Response letter to Reviewers' Feedback for "Look-Ahead SCOPF (LASCOPF) for Tracking Demand Variation via Auxiliary Proximal Message Passing (APMP) Algorithm"

Sambuddha Chakrabarti & Ross Baldick

June 26, 2019

Figure 1: 5 Bus system schematic

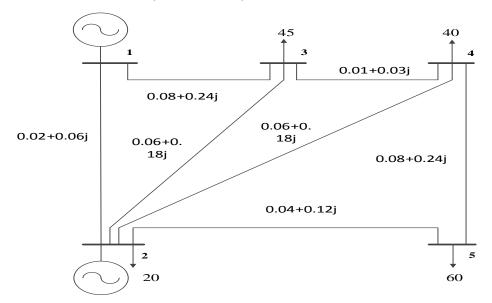
Question 1: The table 1 of the numerical experiment shows the generator data for 5 bus system and only two sets of data are involved it, which needs more data to explain the situation.

Answer: We thank the reviewer for this question. We want to clarify that the reason, there are two sets of data, or two rows of data, to be precise, is that, there are only two generators in the 5 bus system (refer to Figure 1; here, the numbers appearing are the same, as appears in the corresponding tables in the paper manuscript, for the generator capacity, cost coefficients, load, and transmission line data). In the table, we have mentioned all the relevant details, along with the units. However, we would like to ask the reviewer to kindly provide us more specific details regarding what other missing data for what all quantities we need to provide. We will be happy to furnish any relevant data that the reviewer thinks is necessary and is missing.
